ARCHITECT'S SUPPLEMENTAL INSTRUCTIONS

PROJECT:	The Reserves at Cobalt Circle New Development Brownsville, TN	Report No.	Eleven (11)
OWNER:	OPG Cobalt Circle Partners, LLC Dan Maximuk 250 N. Santa Fe Ave, Suite A Salina, KS 67401	Date	February 24, 2026
CONTRACTOR:	MCP Group 3501 SW Fairlawn Rd. Topeka, KS 66614	Architect's Proj No.	24-3446
		Contract For:	General Construction Mechanical, Electrical

C PERGOLA ROOF FRAMING PLAN
 1/4" = 1'-0"

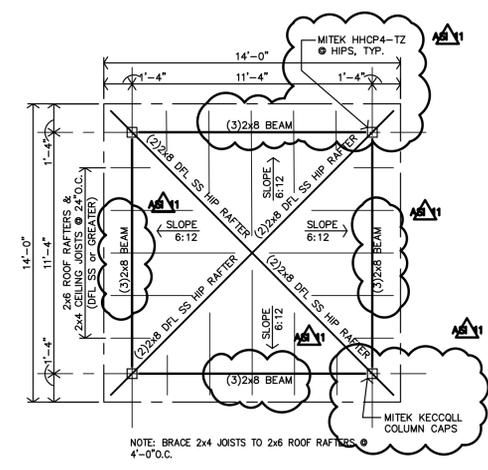
1. Adjustments made to the Pergola, Pavilion and Gazebo based on the Structural' s comments on the Rough Hardware submittal. Revised Details C, F, J, K & L on Sheet A1.5
